INITIAL FIRE SAFETY INSPECTION REPORT

Mondol Fabrics Ltd. (Extension)

RSC ID: 24753

Date: 07th-November- 2023

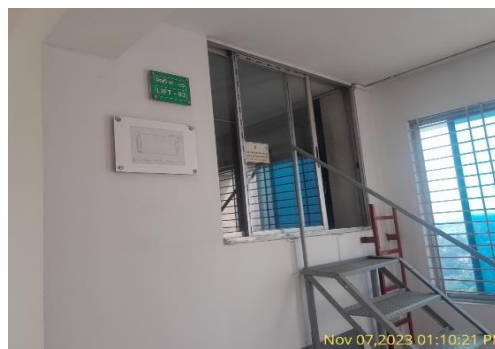
F-3	Fire Rated Construction	Two Elevator shafts directly open into the inside of the exit enclosure & three elevators open into the production floor without proper separation. Location: Exit stair-3 & Exit stair-2 & three elevator open inside floor east side	Modify the elevator shaft as per RSC Technical Guideline (Standard) V1-6.14.3. An exit stairway shall not be built around a lift shaft unless both of them are located in a smoke proof enclosure and made of a material with fire resistance rating required for the type of construction of smoke proof enclosure. So, ensure the lift shaft is 2-hr fire rated including opening protection with similar rating.	Within 3 months
